UNITED STATES PATENT AND TRADEMARK OFFICE

APPLICATION NO.	FILING DATE	FIRST NAMED INVENTOR	ATTORNEY DOCKET NO.	CONFIRMATION NO.
10/777,950	02/12/2004	Tommy Rodrigues	FDN-2797	7092

Office Action Summary	Application No. 10/777,950	Applicant(s) RODRIGUES ET AL.	
	Examiner William V. Gilbert	Art Unit 3635

DETAILED ACTION

Figure 5 from Bondoc

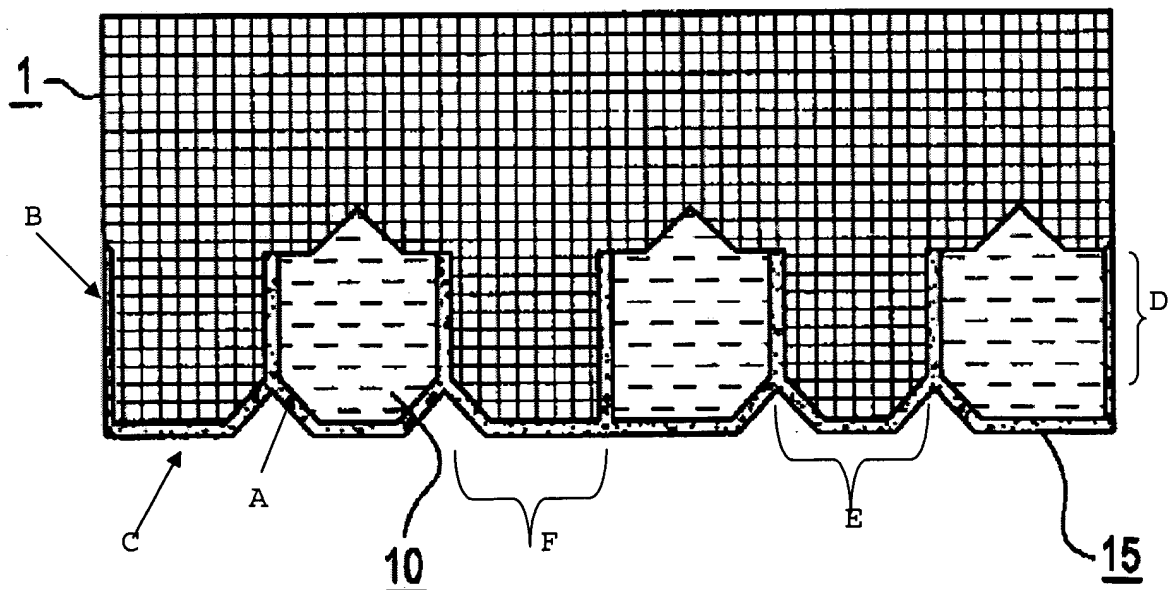
Regarding Claims 1, Bondoc discloses a shingle (Figure 5, generally) with an anterior layer (1) and a posterior layer (15), the anterior layer having a head lap (Figure 1, element 3) and a butt (Figure 1, element 4), an alignment notch (Figure 1, element 6), the shingle having outermost bottom left and right corners, and at least one corner (element "A" from attached Figure 5 from Bondoc, below) corresponds to the alignment notch.

Regarding Claim 3, the notch (6) has a triangle shape and a corner corresponds to a side of the triangle (element "A" from attached Figure 5 from Bondoc, above).

Regarding Claims 8, 29, 34, 35 and 52, Bondoc discloses a shingle with at least one layer (per Claim 29), a posterior layer (15, per Claims 8, 34, 35, 52) with a head lap (element "B" from attached Figure 5 from Bondoc, above, per Claim 8, 52) and tabs (element "C" from attached Figure 5 from Bondoc, above, per Claim 8, 52), an anterior layer positioned on the posterior layer (1, per Claims 8, 34, 35, 52), an anterior head lap (Figure 1, element 3, per Claims 8, 35, 52), an alignment notch (Figure 1, element 6, per Claims 8, 35, 52) and at least one anterior tab (Figure 1, element 2) positioned on the posterior tabs (per Claims 8, 52), and the anterior layer and posterior layer form a shingle, the shingle has outermost bottom left and right corners, and at least one corner that corresponds to the alignment notch (see "A" above: see rejection of Claim 1 above for argument addressing *corresponds*). The phrases "formed from...length", per Claim 29, line 1, "formed from...layer", per Claim 34 line 3 and "formed from...length" per Claim 35, line 3, "formed from...layer" per Claim 52 line 3 are statements of the

proximate element 42 where dotted line represents how the two headlaps may align, per Claim 19) and the posterior head lap extends beyond the anterior head lap (element "D" from attached Figure 5 from Bondoc, above, where the posterior head lap extends beyond the anterior headlap, per Claim 21).

Regarding Claim 25, the anterior tab (2) has a corner that corresponds to the alignment notch (see area proximate element A from attached Figure 5 above).

Regarding Claim 26, the posterior tabs (element "C" from attached Figure 5 from Bondoc, below) have corners (area proximate "A" above) that correspond to the alignment notch (6).

Regarding Claim 27, the anterior tab is positioned substantially centered on the posterior tab (element "E" from attached Figure 5 from Bondoc, above).

Regarding Claim 28, the anterior tab is positioned offset from the posterior tab (element "F" from attached Figure 5 from Bondoc, above).
